REFERENCE: RECON 26/1004

PROPOSAL: DEMOLITION OF THE FORMER DAYCARE CENTRE BUILDINGS AND THE CONSTRUCTION OF 6 NO DWELLINGS, ACCESS ROAD, TURNING AREA AND ASSOCIATED WORKS

SITE: Kensington Court Day Centre Oaklands Road Newport NP19 8GQ

RECOMMENDATION: ADDITIONAL INFORMATION & REVISION REQUIRED (Please re-consult when received)

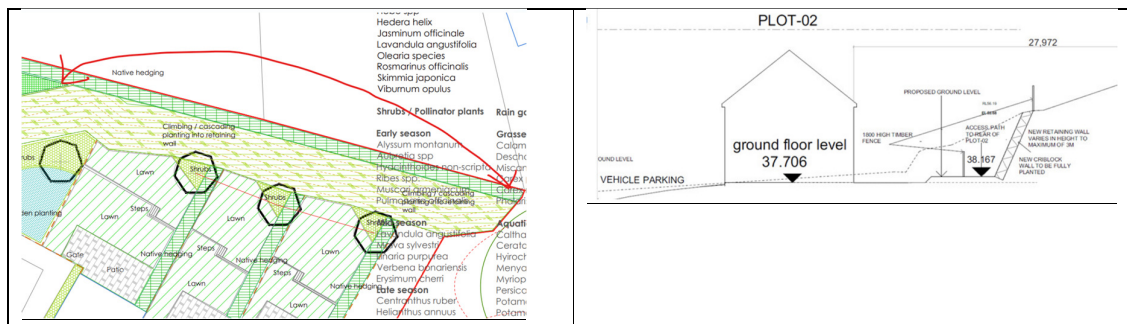
I still have a number of concerns, I appreciate the covering letter which feeds back on my earlier comments but the fact remains there is no room for meaningful structural landscape areas at the plot frontages.
